South Texas Project Electric Generating Station 4000 Avenue F – Suite A Bay City, Texas 77414

May 29, 2008
ABR-AE-08000039

South Texas Project
Units 3 and 4
Docket Nos. 52-012 and 52-013
Requests for Additional Information on STP 3 & 4 COLA

Figure 2.15-3 Site Area Map

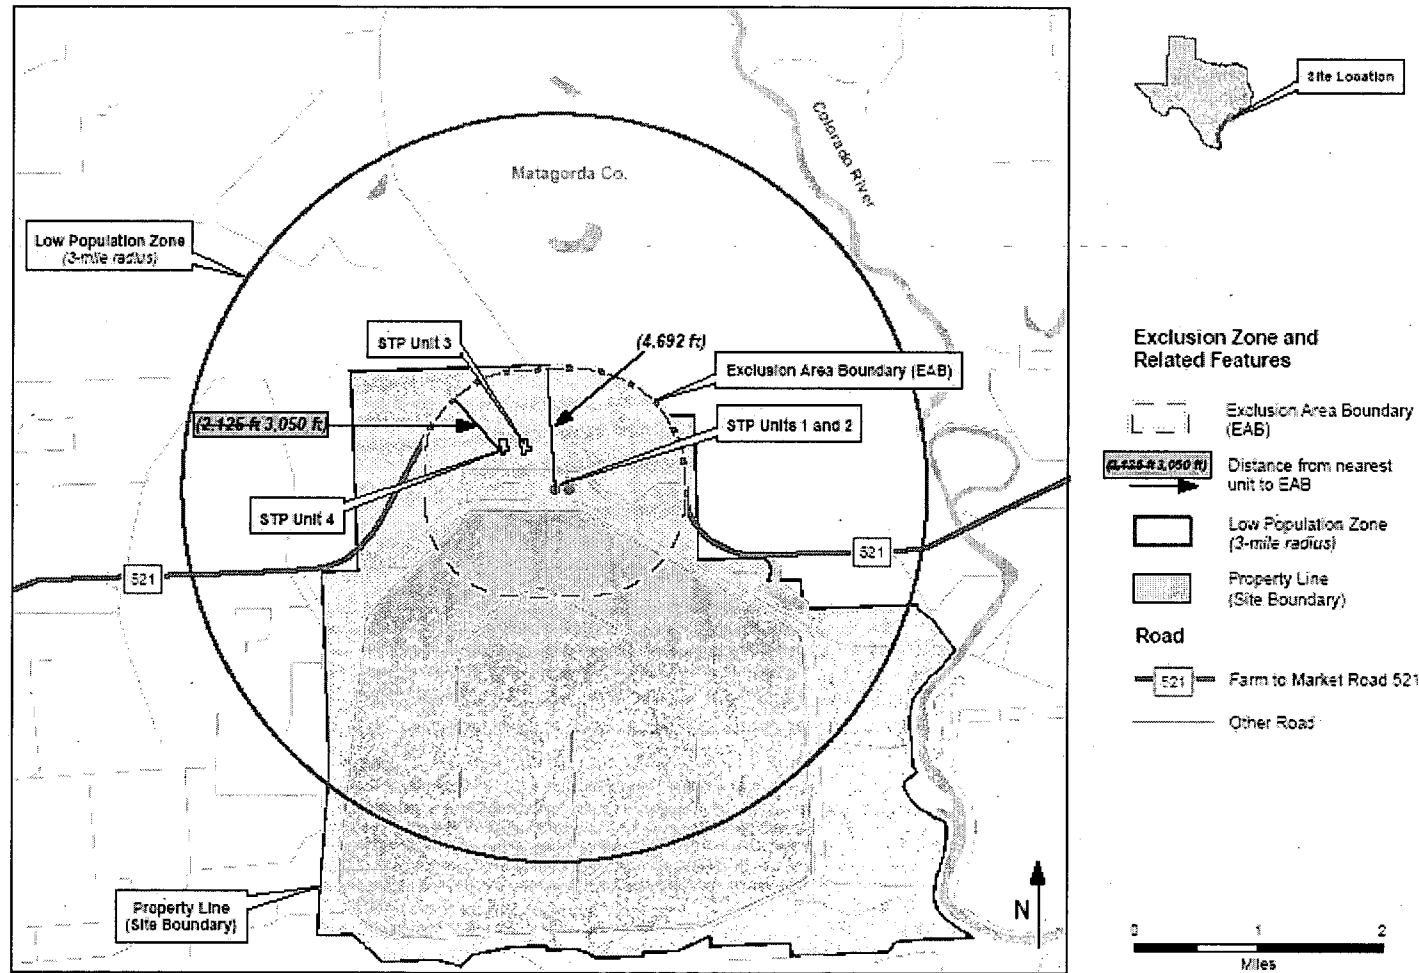
From the STP 3 and 4 FSAR Figure 2.1S-4, it is estimated that the minimum distance to EAB from Unit 4 is about 3050 ft. This value is also confirmed from the FSAR Table 2.3S-22 (Page 2.3S-96). But on the STP 3 and 4 FSAR Figure 2.1S-3, the minimum distance to EAB from unit 4 is labeled both on figure and in legend as 2125 ft. Please clarify and correct as appropriate.

FSAR Figure 2.1S-3 will be modified to reflect the actual distance (3,050 ft) from the centerline of the Unit 4 Reactor Building to the EAB as shown in Attachment 1. The 2,125 ft distance previously identified on the figure and the legend reflected the distance from any potential release point (closest edge of the power block area) to the EAB.

Figure 1

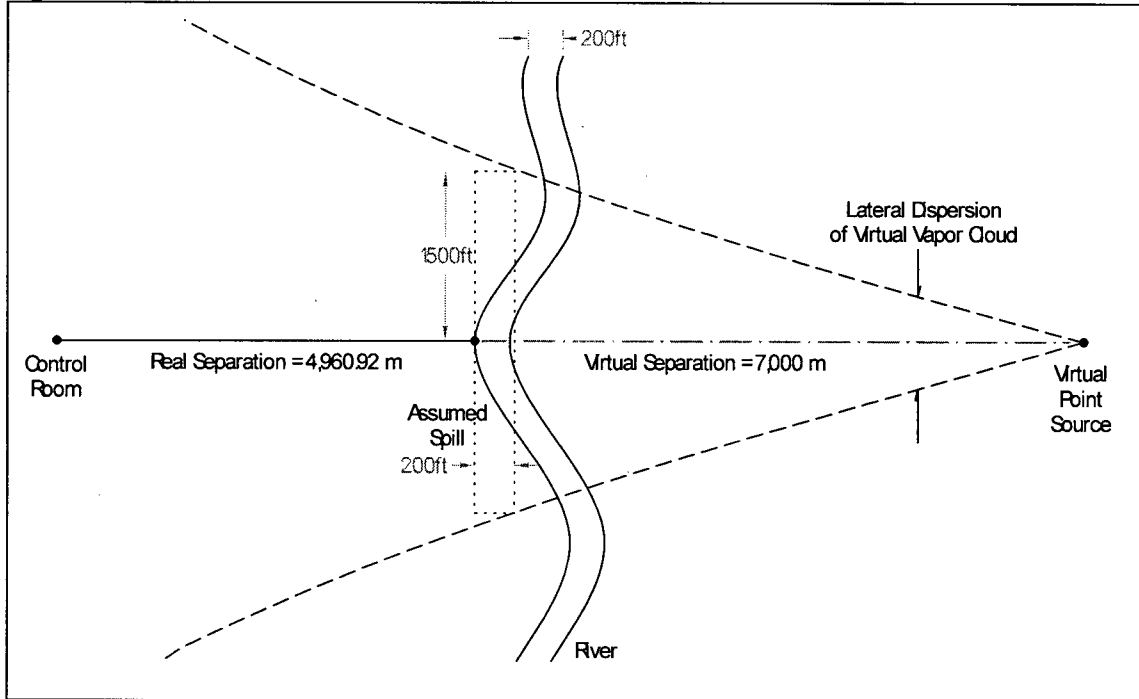
Provide sample inputs, and any assumptions made for ALOHA and DEGADIS models used in determining minimum safe distance required for an explosion to have less than one (1) psi peak incident pressure impact due to flammable vapor cloud.

Downwind Distance	39,241.8 ft (11,960.92m)	$\sigma_{yo} = s/4.3 = (3000/4.3)=697.674 \text{ ft}$ This correlates to a downwind distance of 7,000 m. Therefore, L= (4,960.92m) + (7,000m)= 11,960.92m (see Note 3 and Figure 1)
Quantity Spilled	1,680,000 gallons	The barge transports in quantities of up to 40,000 BBLs or 1,680,000 gallons (6,359.5m ³). (Reference 11)
Air and Water Temperature	84.1°F = 28.9°C = 302.1 K	To maximize evaporation rate, the July mean temperature is used. (Reference 16) Assuming the water temperature to be the same as the air temperature is conservative as the temperature of the Colorado River is consistently cooler than the air or ground temperature. (Reference 13)
Relative Humidity	50%

This virtual distance represents the generation of a vapor cloud from a point origin that would be of an equivalent cloud size when it reaches the "real" distance at the river. (See Figure 1 below.)

FIGURE 1. Counties Considered Within the 77.91-Mile-Radius Circle

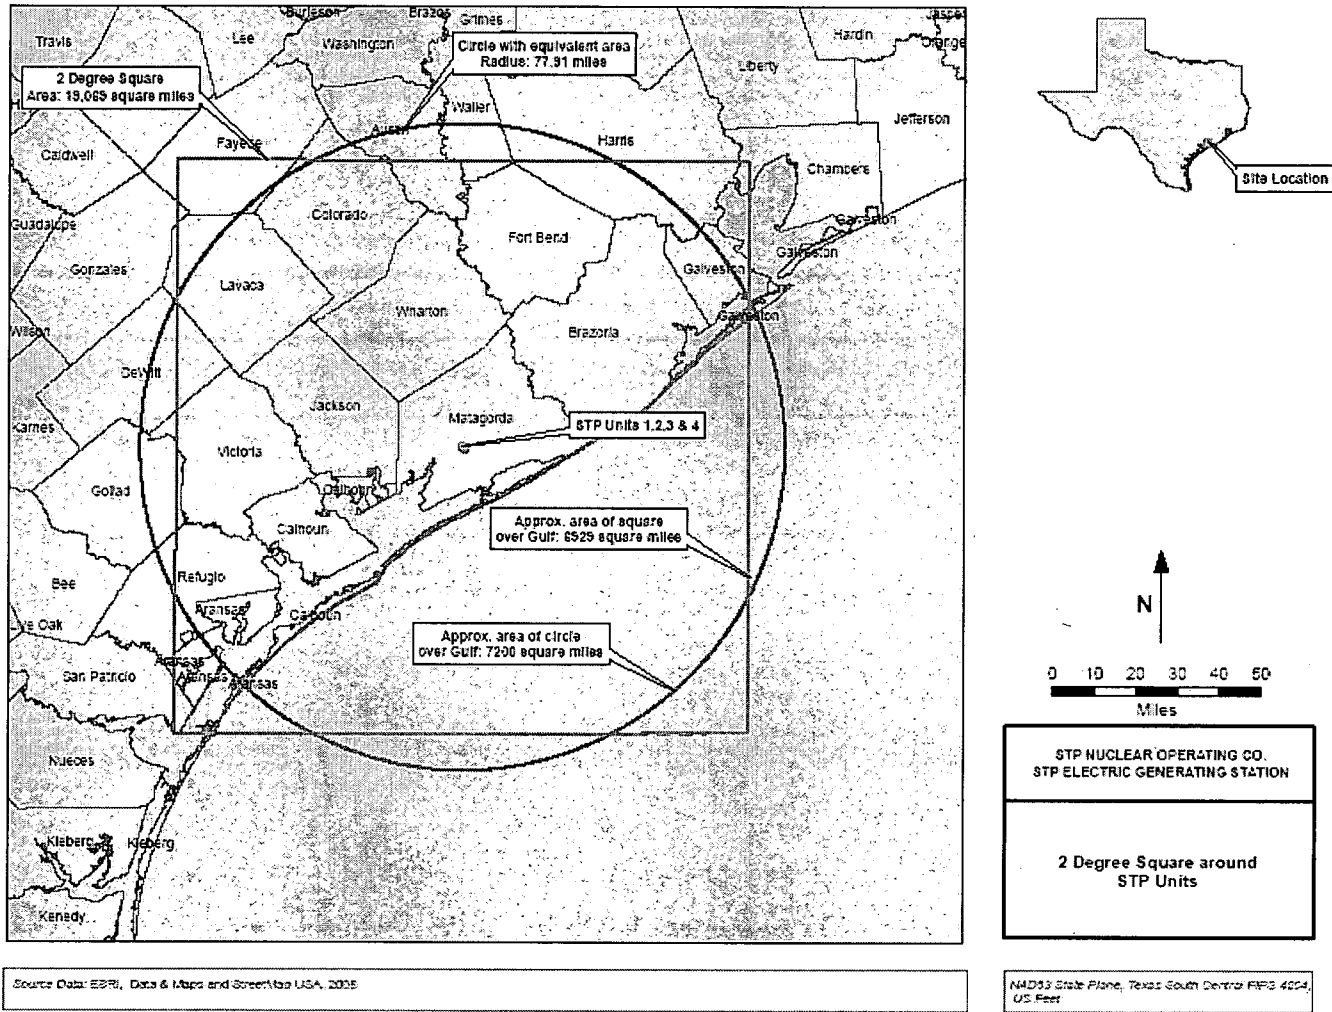
Provide statistics on the frequency of occurrence of tornadoes in the STP site region.

The STP site is located about N 28° 48' (latitude) and W 96° 3' (longitude). Figure 1 of Regulatory Guide 1.76 uses the 2° boxes to classify tornado intensity regions for the contiguous United States. As a time saving alternative to account for number of tornadoes that occurred nearby the STP site, a circular area was used in order to be equivalent to the approach used by a data retrieval application developed by the National Severe Storms Laboratory (NSSL), called Severe Plot. (<http://www.spc.noaa.gov/software/svrplot2>). As shown in Figure 1, the circle with a 77.91-mile-radius centered at the STP site covers the same area as the 2° box. To be conservative, all tornadoes were included in this analysis for counties that are either totally or partially covered by the 77.91-mile-radius circle.
